County of Hawaii
PLANNING DEPARTMENT

November 25, 2008

Subject: Ohana Dwelling Unit Permit Application (OHD-08-000117)
Applicant(s): Ms. Fujie Yoshizawa
Land Owner(s): Ms. Fujie Yoshizawa and Alvin Yoshizawa
Proposal: Construct An Attached Ohana Dwelling Unit
Tax Map Key: (3) 1-6-142:045

The subject Application for an Ohana Dwelling Unit Permit was reviewed by the required agencies and their respective comments are as follows:

MRS. FUMIE YOSHIZAWA
KEADU LOOP
TKK (3) 1-6-12
SITE PLAN
50' 1" = 20'

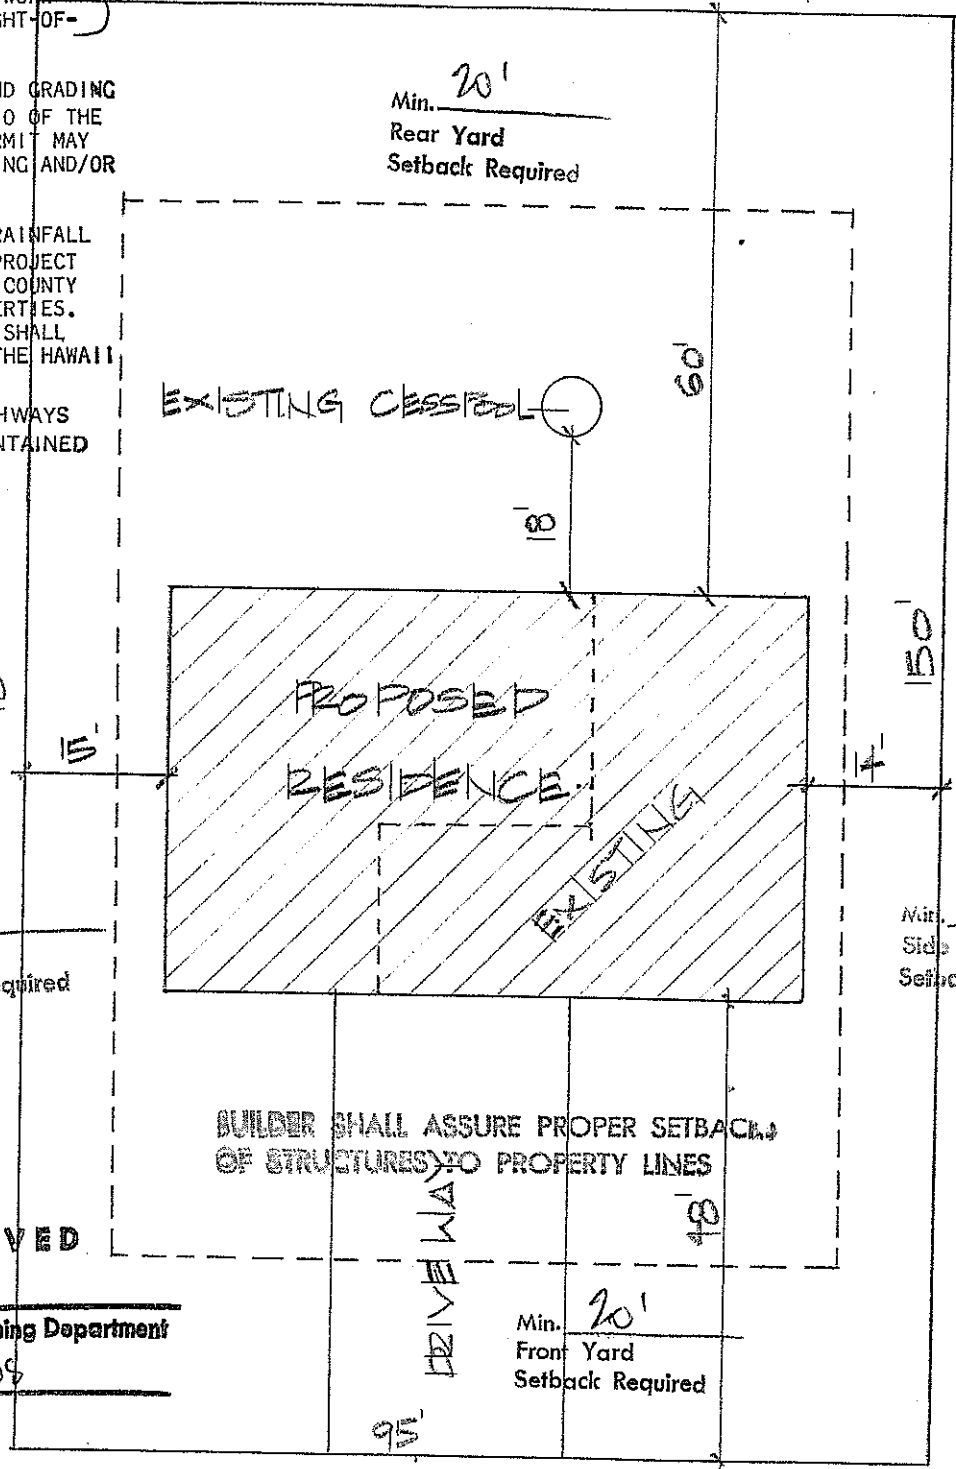
DRIVEWAY: IN ACCORDANCE WITH CHAPTER 22 OF THE HAWAII COUNTY CODE, A PERMIT SHALL BE OBTAINED FOR DRIVEWAY CONSTRUCTION WORK WITHIN THE COUNTY ROAD RIGHT-OF-WAY.

GRADING: ALL EARTHWORK AND GRADING SHALL CONFORM TO CHAPTER 10 OF THE HAWAII COUNTY CODE. A PERMIT MAY BE REQUIRED FOR LOT GRUBBING AND/OR GRADING.

RAINAGE: NO ADDITIONAL RAINFALL RUNOFF GENERATED BY THIS PROJECT SHALL BE DISPOSED OF ONTO COUNTY ROADWAYS OR ADJACENT PROPERTIES. ALL DRAINAGE IMPROVEMENTS SHALL CONFORM TO CHAPTER 27 OF THE HAWAII COUNTY CODE.

ROADWAY: CHECK WITH HIGHWAYS DIVISION IF ROADWAY IS MAINTAINED BY COUNTY OF HAWAII
